## Durita, Colorado, Disposal Site Inspection Report, May 22, 2008

Participants: Dave Holland, Hecla Mining Co; Earl Reams, Reams Construction; Edgar Ethington, CDPHE; Tracy Ribeiro, DOE; Cheri Bahrke, Stoller; Marilyn Kastens, Stoller; Mike Widdop, Stoller

Northwest corner of site showing fence encroachment; looking east, visitor standing at boundary monument.

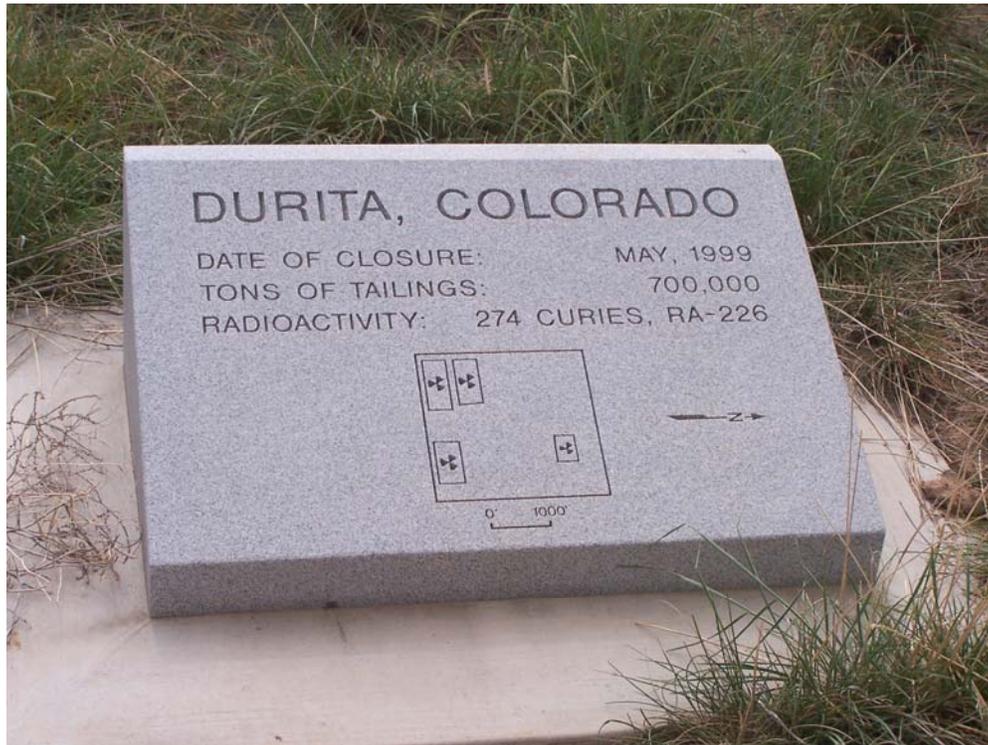
Fencing has been installed outside the site boundary on the west and north sides of the site. At the northwest corner, the encroachment appears to be 17 feet onto the private property to the west and 36 feet onto BLM property to the north, based on the location of the survey monument. The licensee must resolve this issue before transition.

8. The licensee must resolve the issue of fence encroachment.
9. Debris, mostly tumbleweeds, accumulates against the fence in places. Removal may be necessary if the debris interferes with drainage and this item will be added to the inspection checklist.
